# Access Compliance Report

## Public Rights-of-Way

### (Curb Ramps)

Intersection ID: 7812	Main Street: SQUIRREL_HILL_RD	Cross Street: THORNWOOD_RD	Location: S
ADA ID: D5FAFBCB448D	Ramp Type: Perp	Initial Pass/Fail: Fail	Overall Compliance: No
Severity Score: 10			
Codes/Mitigation Info/Possible Solution		Field Measurements/Component Compliance

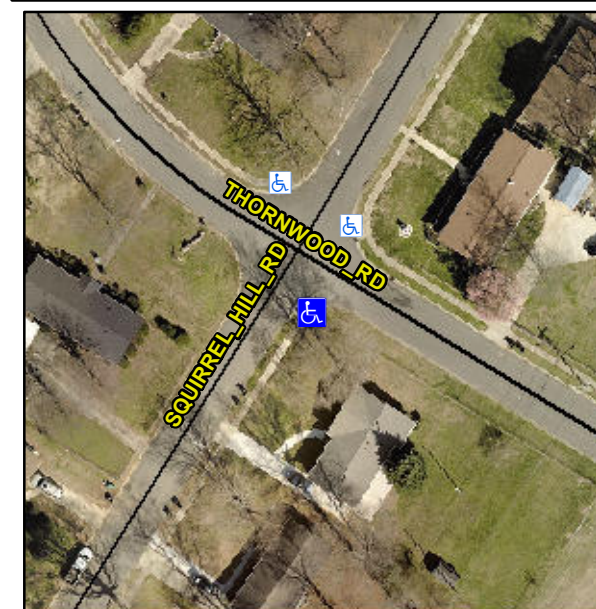
**Not Found, R304.5.1, R304.5.3**

Compliance	Description	Data	Compliance	Description	Data
N/A	Ramp Length (in)	47.5	Yes	Ramp Slope (%)	5.7
No	Ramp Width (in)	41.0	No	Ramp XSlope (%)	2.5
N/A	Flare Type LT	N/A	N/A	Flare Type RT	N/A
N/A	Flare Slope LT (%)	N/A	N/A	Flare Slope RT (%)	N/A
N/A	Flare Traversable LT?	N/A	N/A	Flare Traversable RT?	N/A
N/A	Landing Length (in)	N/A	N/A	DWS Provided?	N/A
N/A	Landing Width (in)	N/A	N/A	DWS Contrast?	N/A
N/A	Landing Slope (%)	N/A	N/A	DWS Length (in)	N/A
N/A	Landing X Slope (%)	N/A	N/A	DWS Full Width?	N/A
N/A	Landing Curb? (Y/N)	N/A	N/A	DWS Offset (in)	N/A
N/A	Shared Landing?	N/A			
N/A	Gutter Ponding?	N/A	N/A	Gutter Slope (%)	N/A
N/A	Gutter Lip Ht (in)	1.0	N/A	Gutter X Slope (%)	N/A
N/A	Painted X Walk1?	No	N/A	Painted X Walk2?	N/A
	X Walk 1 Direction	To NE		X Walk 2 Direction	N/A
N/A	X Walk 1 Width (in)	N/A	N/A	X Walk 2 Width (in)	N/A
	X Walk 1 Slope (%)	4.6		X Walk 2 Slope (%)	N/A
	X Walk 1 X Slope (%)	0.2		X Walk 2 X Slope (%)	N/A

**Remove & Replace Entire Ramp.**
